2. Major Difference (from previous model)

3. Exhaust System

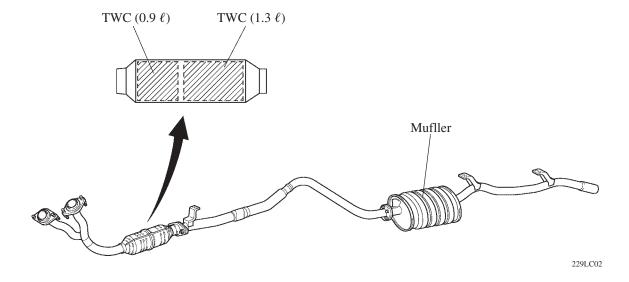
Item	Outline		
Intake and Exhaust System	Addition of TWC*1		
	• Changed composition of TWC*2		
	• Discontinuance of air cleaner warning switch* ³		
Engine Control System	Adoption of the heated oxygen sensor*1		
	Discontinuance of variable resister*4		
Other	Configuration and structure are the same as previous model* ³

Two TWCs are used in order to comply with the European STEP II regulations.

Location	New*1			Previous*2		
	Cell Density	Volume	Material	Cell Density	Volume	Material
Front	62 cells/cm ² (400 cells/in ²)	875 cm ³ (53.4 cu. in.)	Ceramic	62 cells/cm ²	1291 cm ³	Ceramic
	62 cells/cm ² (400 cells/in ²)	1291 cm ³ (78.8 cu. in.)	Ceramic	(400 cells/in^2)	(78.8 cu. in.)	Ceramic
